RE: Lot 33 Block 6 Unit 2 Volcano Cliffs SAD 227 7912 Kibo NW Grading and Drainage Plan

Engineers Stamp Date 10/2/17 (E10D039)

DRAINAGE AND TRANSPORTATION INFORMATION SHEET (REV 09/2015)

7912 KIBO GRADING AND DRAINAGE PLAN 21805-LAYOUT-9-28-1

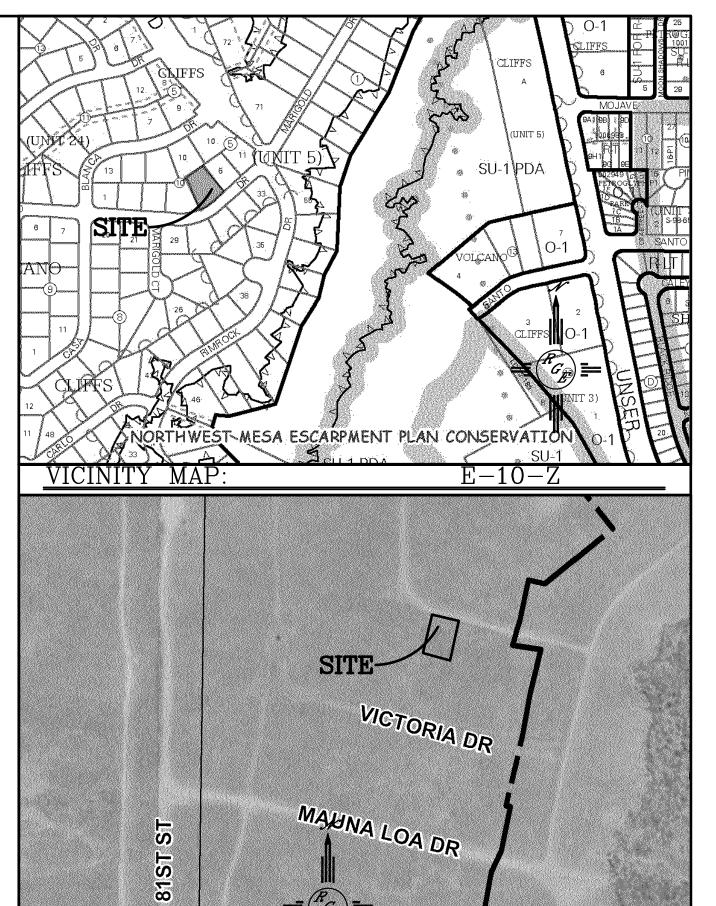
Based upon the information provided in your submittal received 10/2/17, this plan is approved for Grading Permit.

Prior to Building permit approval a Pad Certification will be required, provided by the Engineer with pad cert language or a registered Land Surveyor with as build spot elevations on approved grading plan dated 10/2/17.

Reiterate to the Owner/Contractor that a separate permit for a garden/retaining wall must be obtained, with the approved G&D and Pad Certification.

Prior to Certificate of Occupancy release, Engineer Certification per the DPM checklist of this plan will be required.
